PERSIMMON HOMES THAMES VALLEY
NORTH LITTLEHAMPTON
FITZALAN LINK S278 WORKS
LITTLEHAMPTON, WEST SUSSEX

STAGE 1 - ROAD SAFETY AUDIT
ADDENDUM

Project Code:	S/PHFITZ.1.1AD.6a
Prepared by:	Martyn Parr
Approved by:	John Reid
Issue Date:	August 2017
Status:	FINAL

drawing number
PHF-MB-S278-GF-DR-D-210-02
rev.
P7

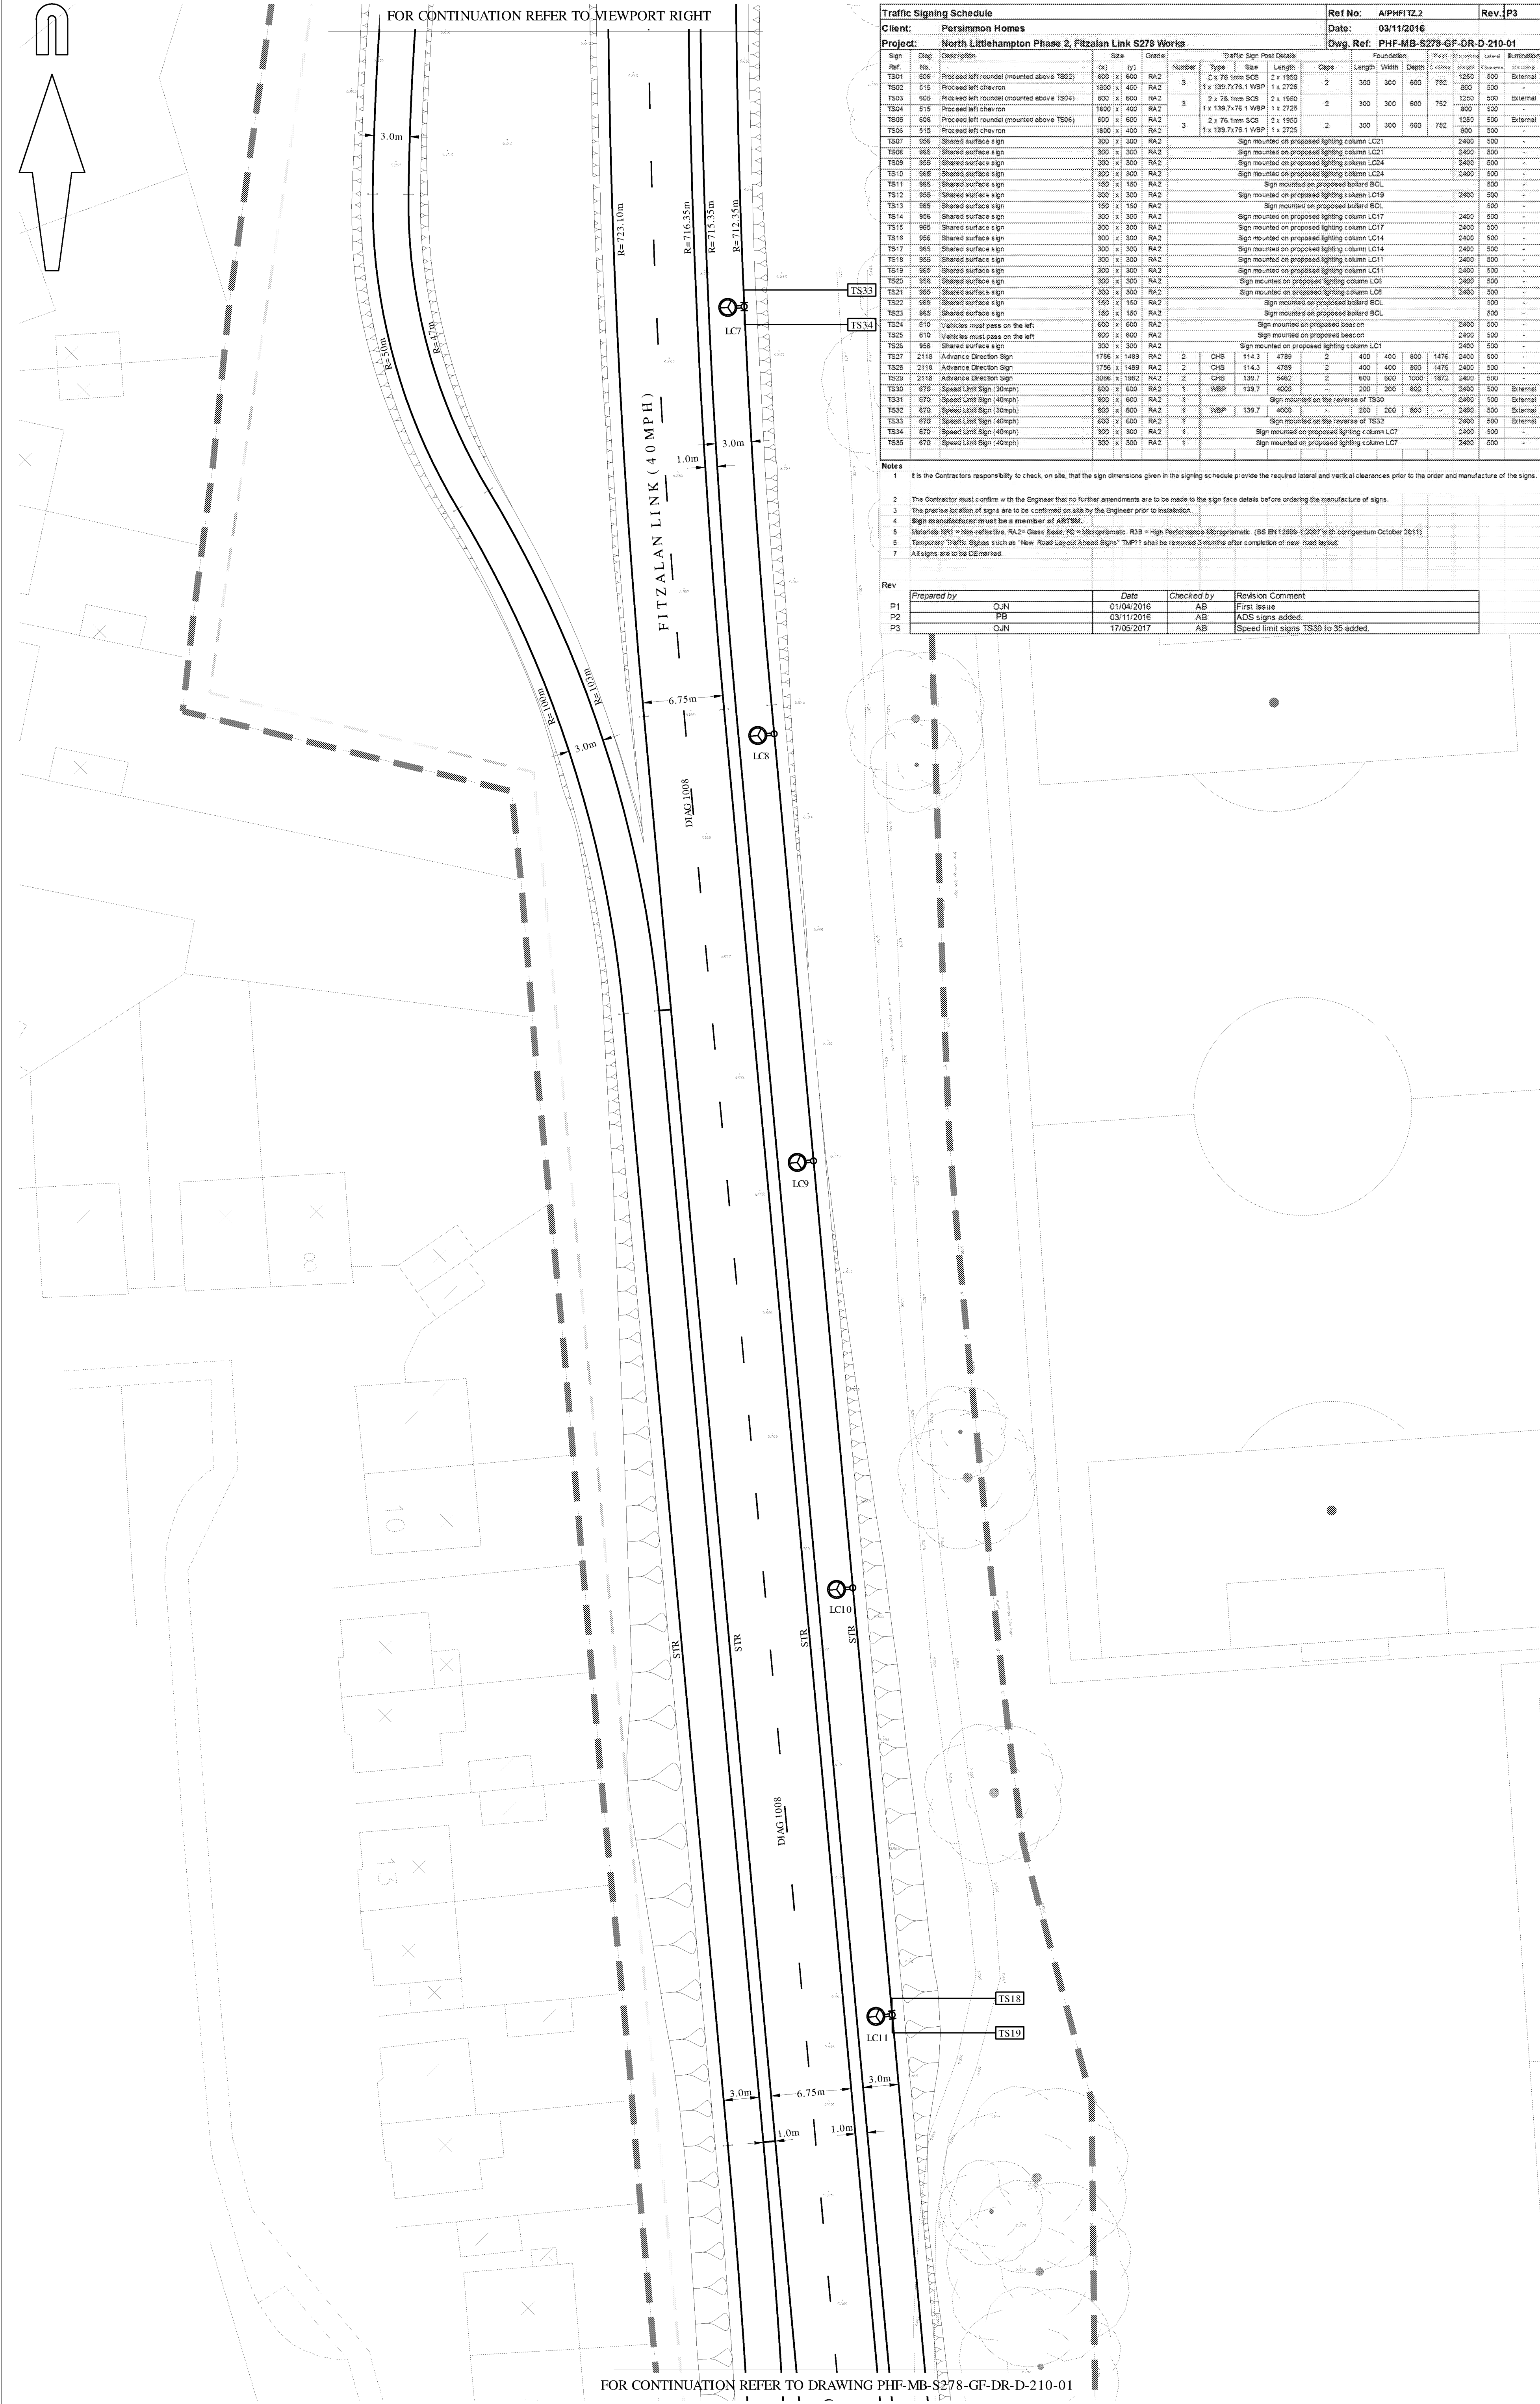
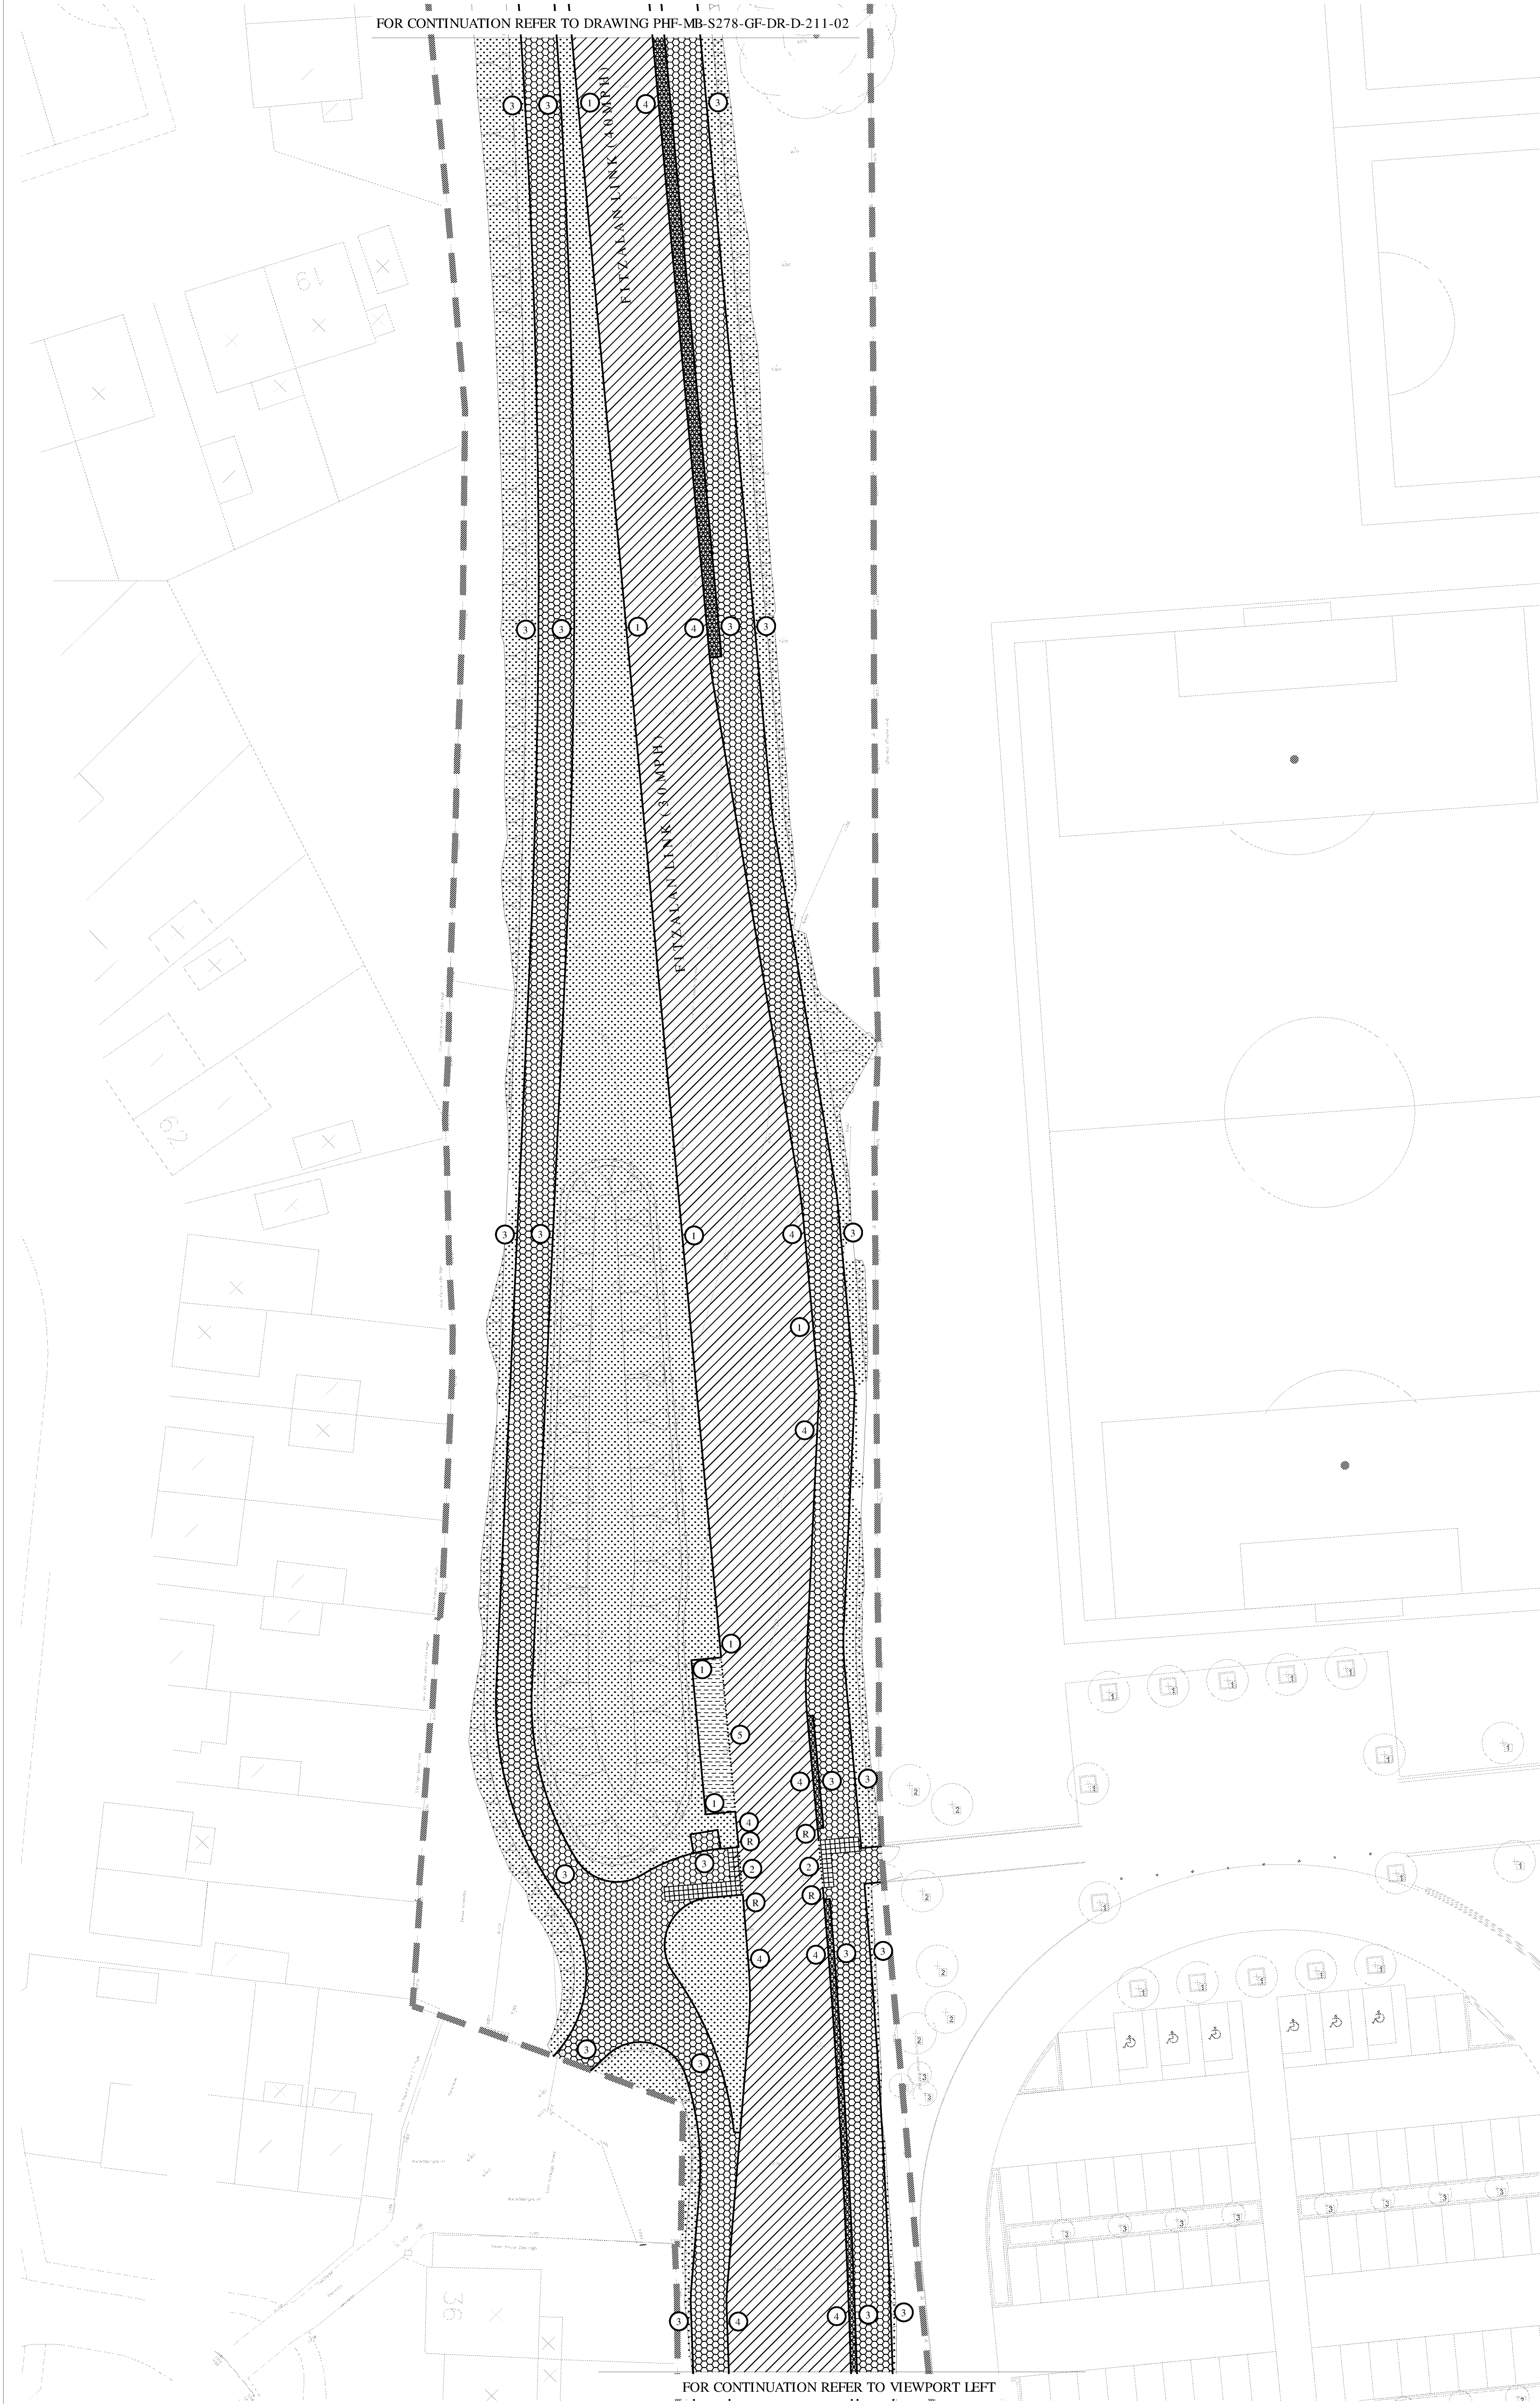
Location: Fitzalan Link Road (please refer to reference point 2.5 in Appendix B)

Summary: Incorrect roundels provided on traffic island

The traffic bollards to be provided on the proposed traffic island will have plain face roundels, indicating that vehicles can pass either side of the island. This could result in vehicles passing the island on the offside resulting in a head on type collision with an oncoming vehicle.

Ensure 'keep left' roundels are provided on the proposed traffic bollards.
